Subject Re. photo no. 15/3 & 15/4, Jan 2

NOTICE UNDER SCHEDULE VI CHAPTER XI, RULE 2 (1) OF
THE CITY OF KARACHI MUNICIPAL ACT, 1933.

Re: Plot No. 15/3+15/4 J.M.2.
1
Jamshed Quarter.

SHOWING PROPOSED FIRST FLOOR
ON PLOT No 15/3+15/4. SHEET J.M.2.

SHEET No 2.

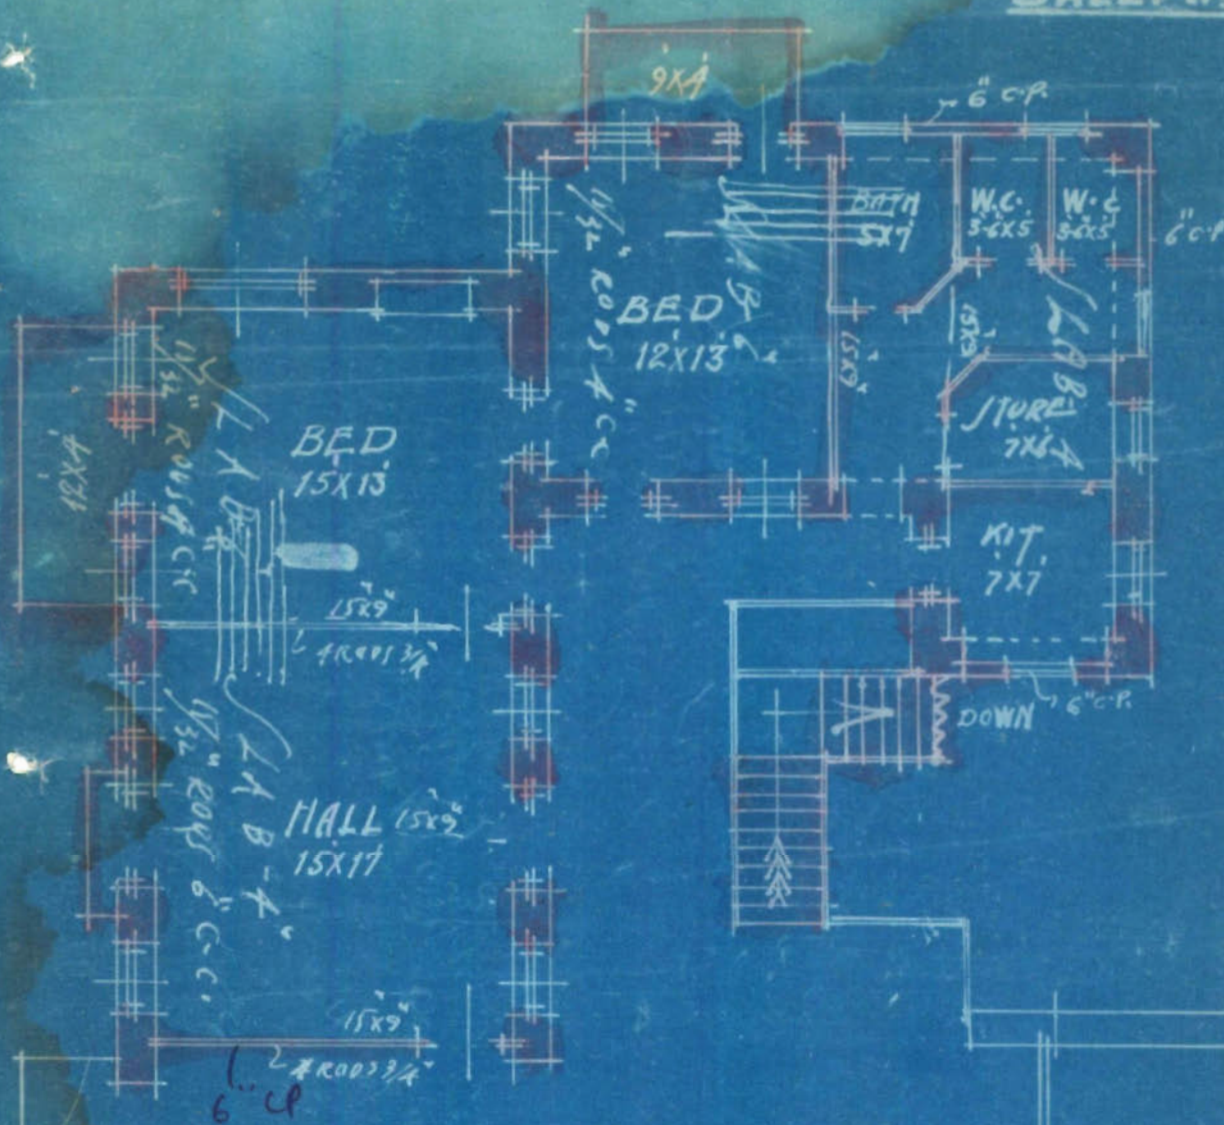
1. Drainage lines should be shown on the plan.
2. Position of overhead tank and arrangement of access to it should also be shown.

1. Plot must be shown as per M given on the plan.
2. Measurements of Sides also must be shown if
3. There is one plot between Plot No. 3 & 4 which is not also shown

1. Plans must be corrected & shown in ink
2. Built up area & measurements as per site.
3. Secretary must sign the plan in form A.

1. Drainage lines should be shown on the plan.
2. Position of overhead tank and arrangement of access to it should also be shown.
3. Plot must be shown as per no. given on the plan.
4. Measurements of sides also must be shown if there is one plot no. 3 and 4 which is not also shown.
4. Plans must be corrected as shown in ink.
5. Built up area and measurements as per site be given.
6. Secretary must sign the plan and forms "A".

We are herewith sending you three copies of
corrected plan of the above plot for favour of your early
approval.

With reference to your letter No.B.S.P.
463/34 dated 15 th. instant, we have the honour to
return the plans duly corrected with all objections
duly complied with.

SHEET NO. 2.

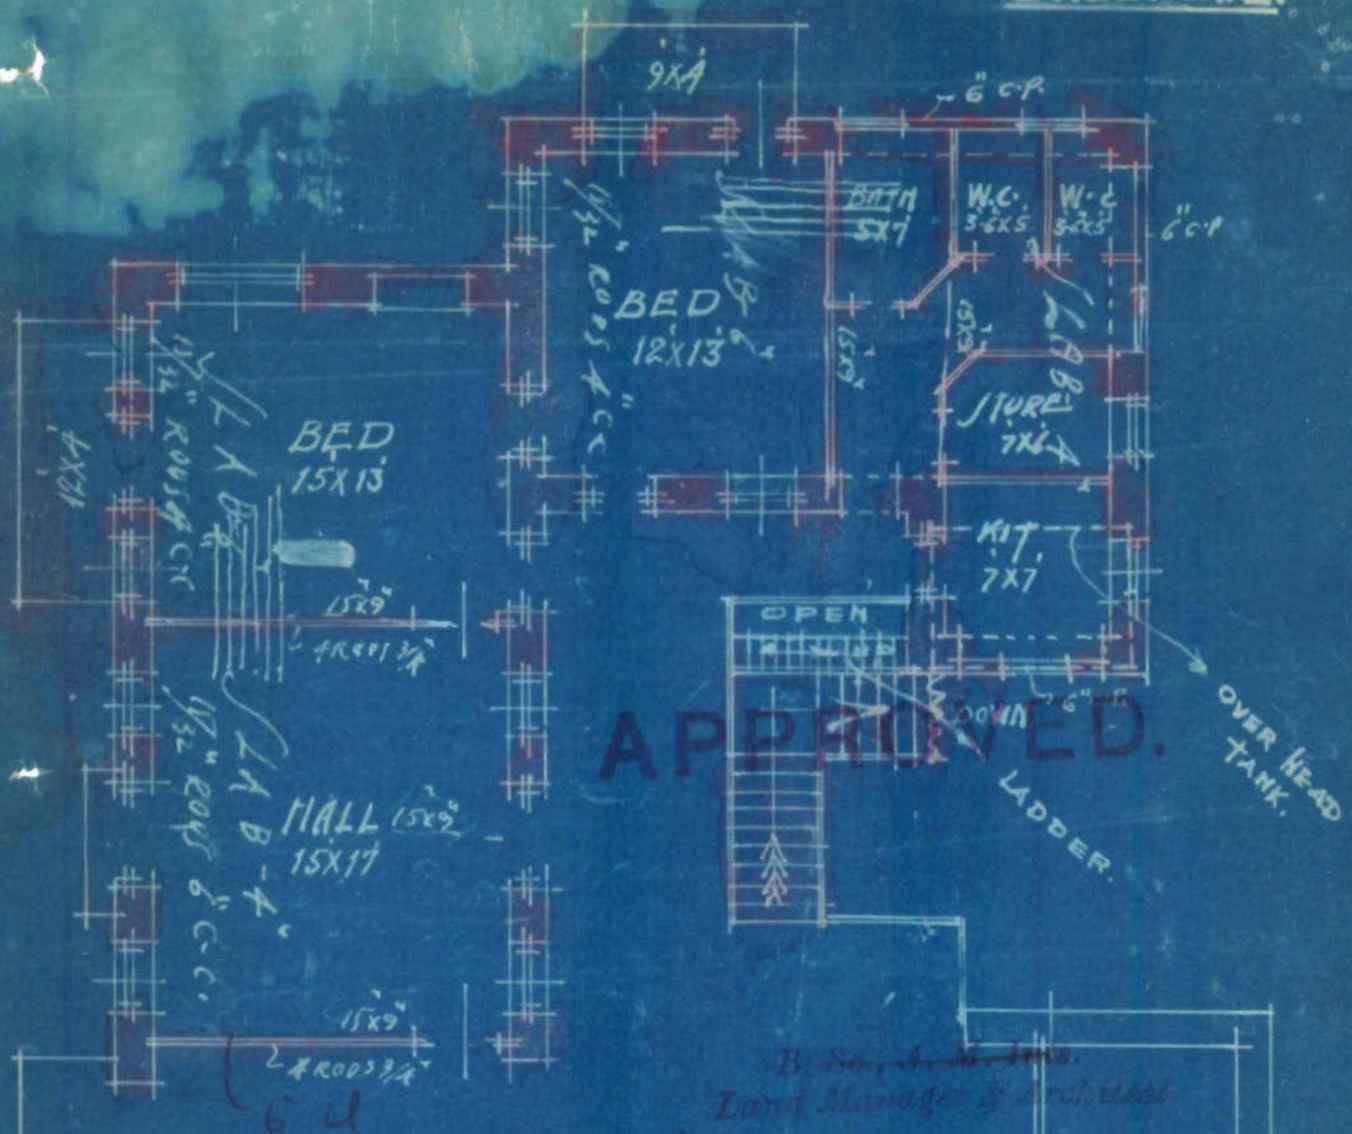
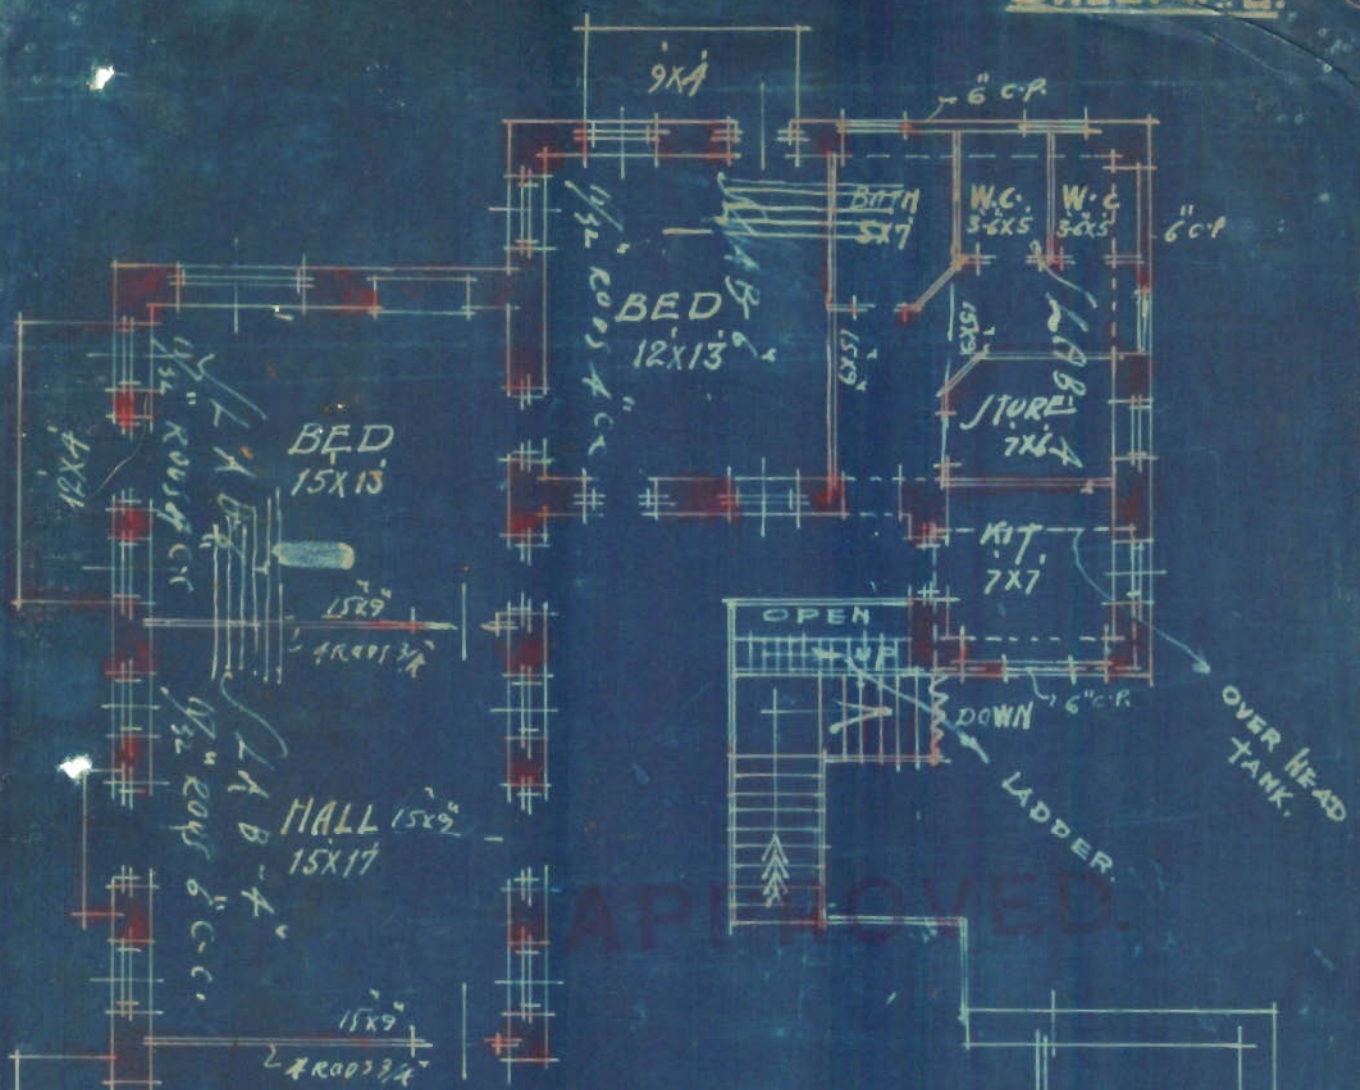
The objections are complied with. But Mr. Thawades
states that L.M.A's orders be asked with regard
to the level of roof of the motor garage which is not
conform at the same level as the main bldg.
K.M. 28/8

1. The level of roof of the motor garage which is not at the same level as the main building is objectionable.

1. The level of roof of the motor garage which is not at the same level as the main building is objectionable.

*Since the owner does not propose to
construct a loft the plan is approved
29/8.*

I do not propose to construct a loft.
